CASE PL201700057

PROJECT: BWE LTE
AT&T SITE ID: MNL03123
FA#: 10081798
PACE#: MRUMW015861
PTN#: 3511A07VHK

MALL OF AMERICA
BLOOMINGTON, MN 55454

PROPOSED BUILDING (NORTH) ELEVATION

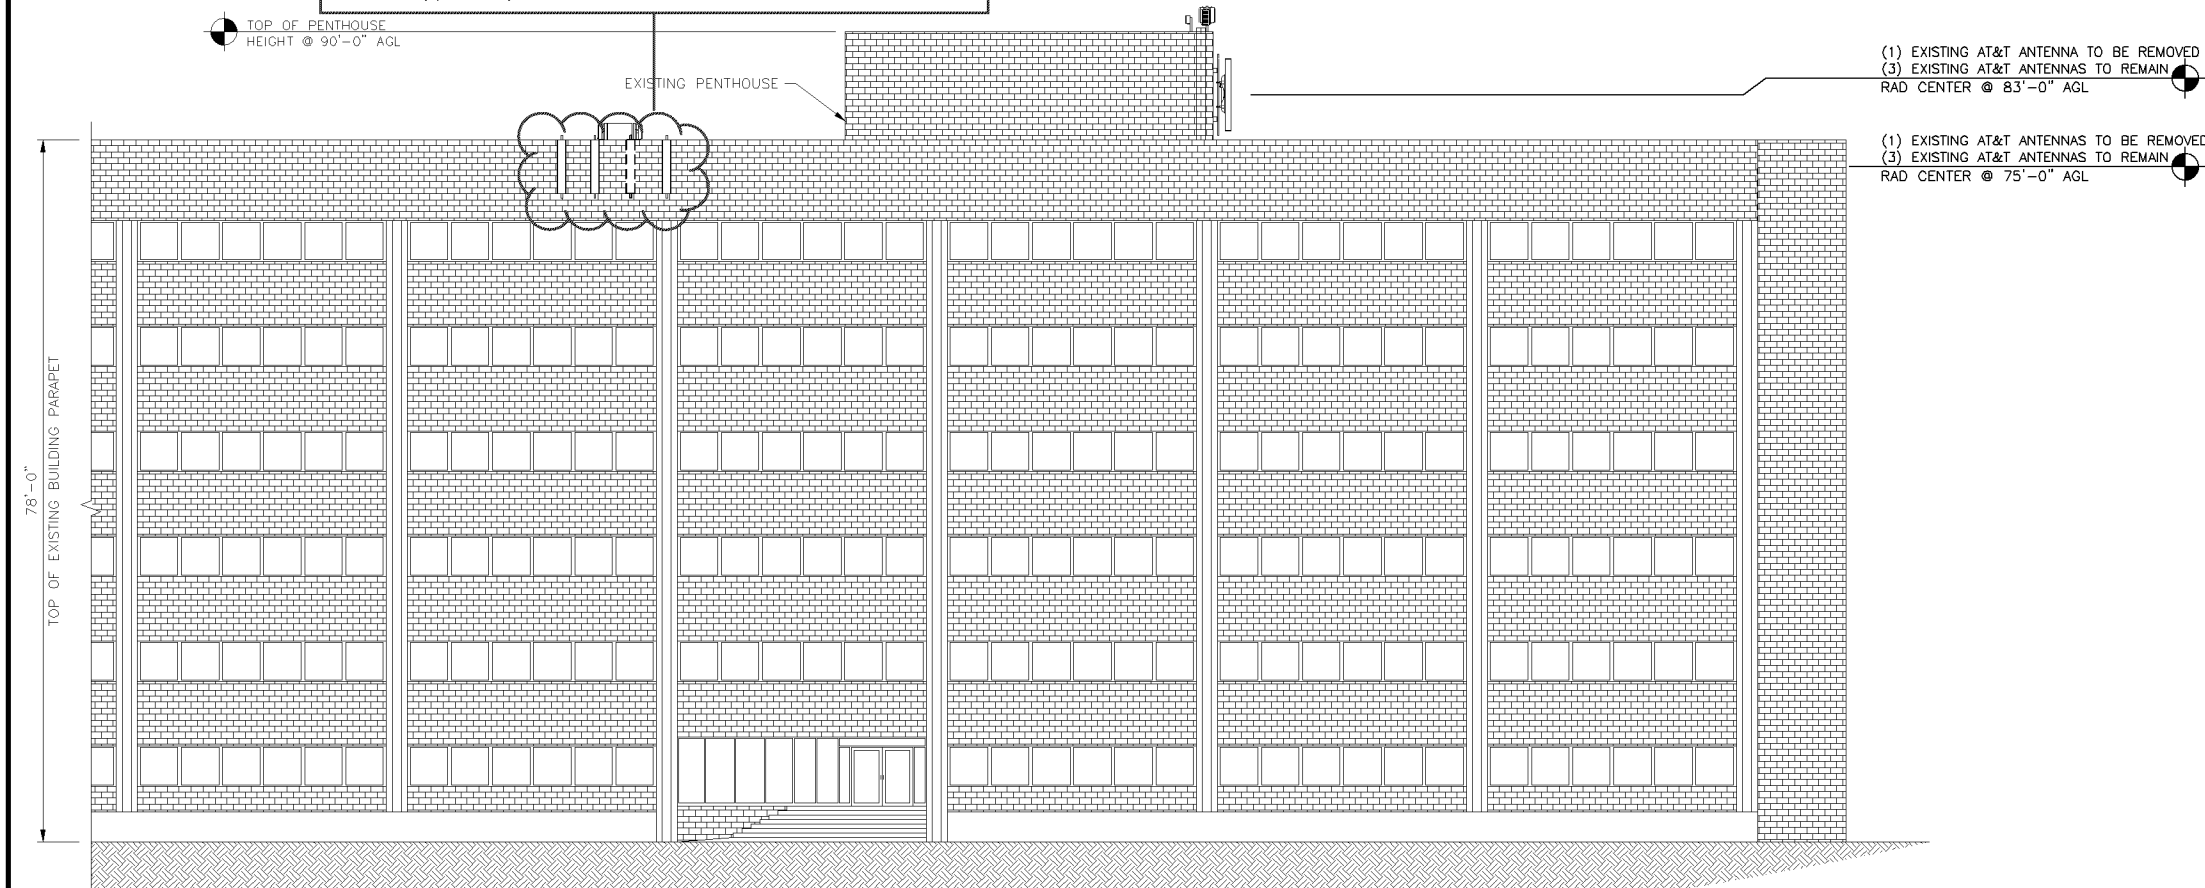
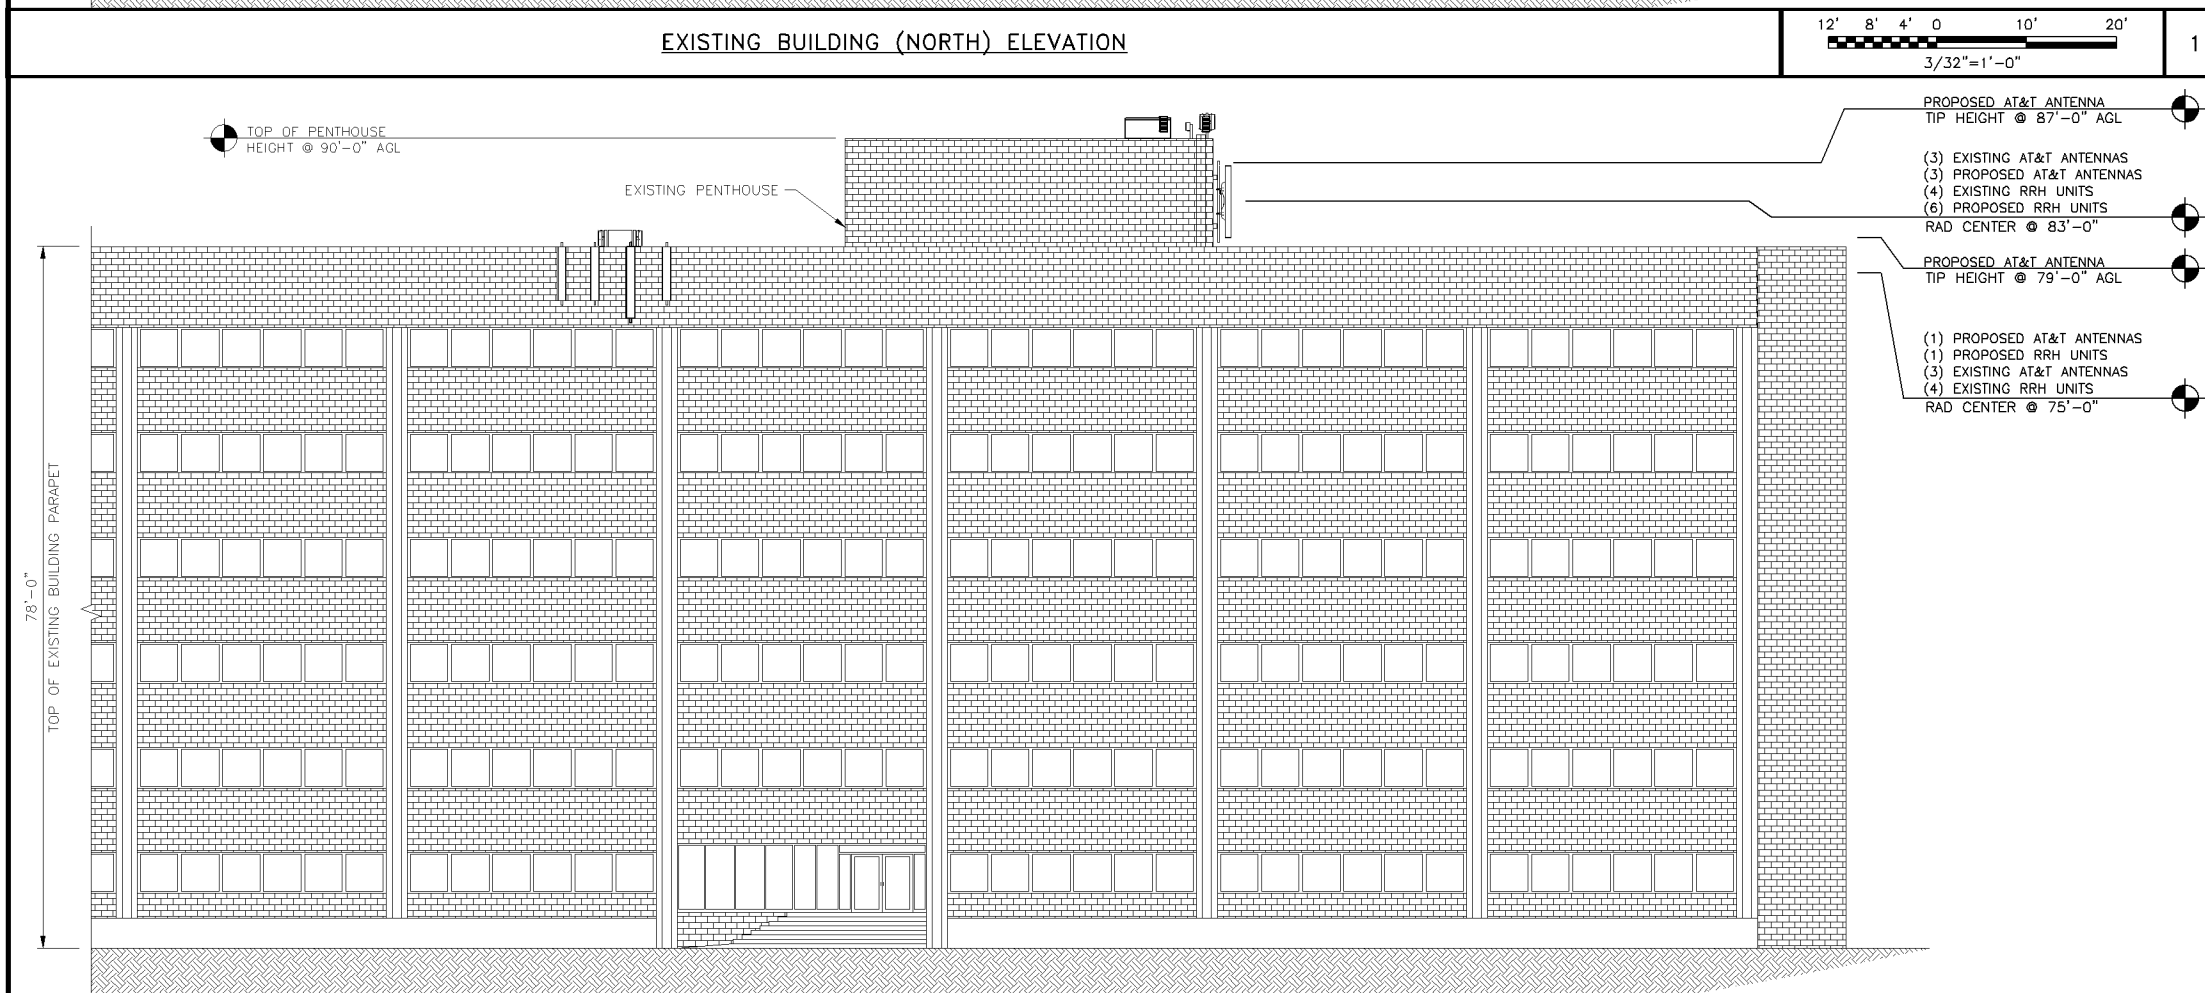
Existing and new antennas must not extend above the wall on which they are mounted. Existing antennas do not presently comply with the approved plans in Case 7986A-11 and must be corrected.

SHEET TITLE
TOWER ELEVATIONS

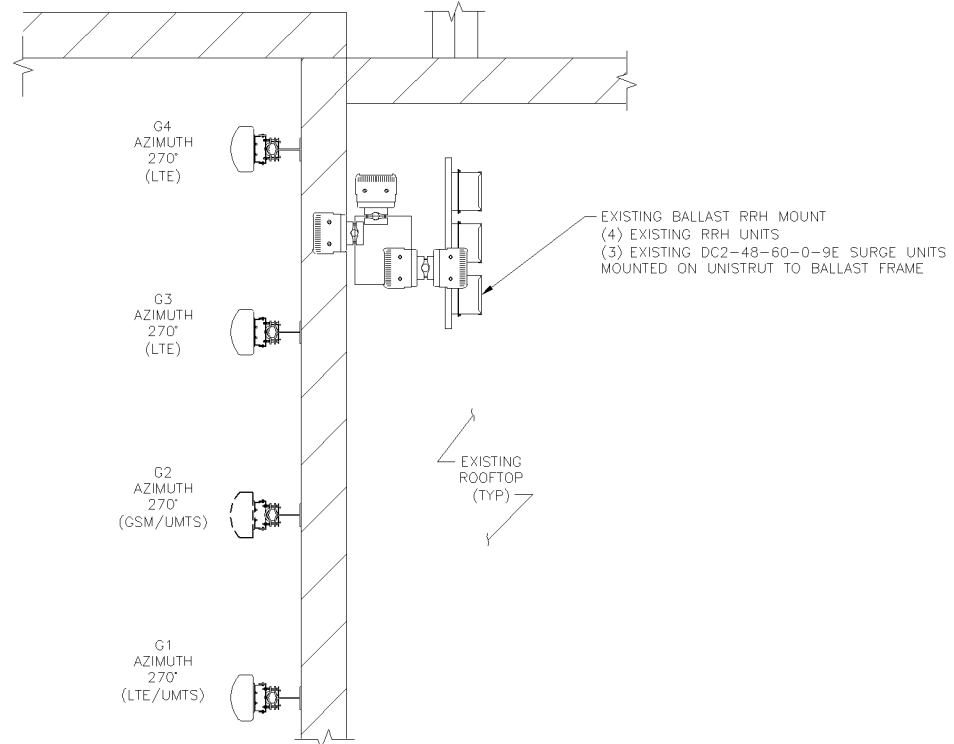
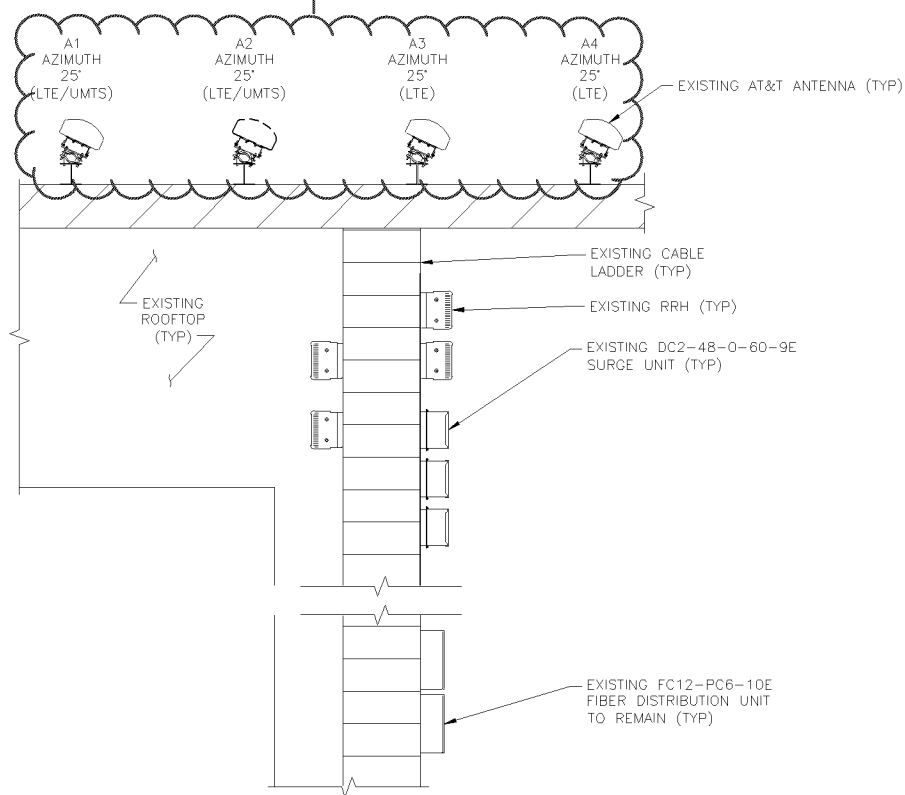
Existing and new antennas must not extend above the wall on which they are mounted. Existing antennas do not presently comply with the approved plans in Case 7986A-11 and must be corrected.
